Mobile Intel® Pentium® 4 Processor-M

Specification Update

March 2006

Document Number: 250721-033

Figure 13. System Bus Reset and Configuration Timings

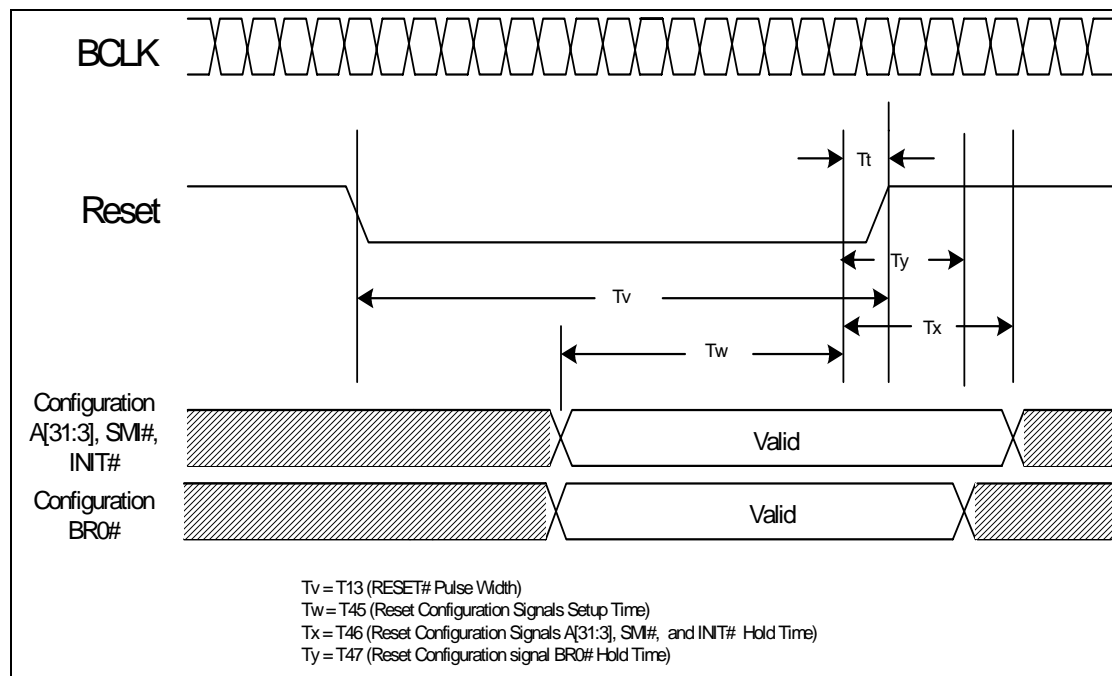
T2. BR0# Maximum Hold Time Specification Change

The BR0# maximum hold time has changed to 2 BCLKs. This change will be shown in the “System Bus AC Specifications (Reset Conditions)” table and “System Bus Reset and Configuration Timings” figure of the *Mobile Intel® Pentium® 4 Processor - M Datasheet*. This change will be incorporated in the next revision of the datasheet.

The following figure will be modified to reflect this change:

T# Parameter	Min	Max	Unit	Figure	Notes
T45: Reset Configuration Signals (A[31:3]#, BR0# INIT#, SMI#) Setup Time	4		BCLKs	13	1
T46: Reset Configuration Signals (A[31:3]#, INIT#, SMI#) Hold Time	2	20	BCLKs	13	2
T47: Reset Configuration Signal BR0# Hold Time	2	2	BCLKs	13	2

1. Before the deassertion of RESET#.
2. After clock that deasserts RESET#.
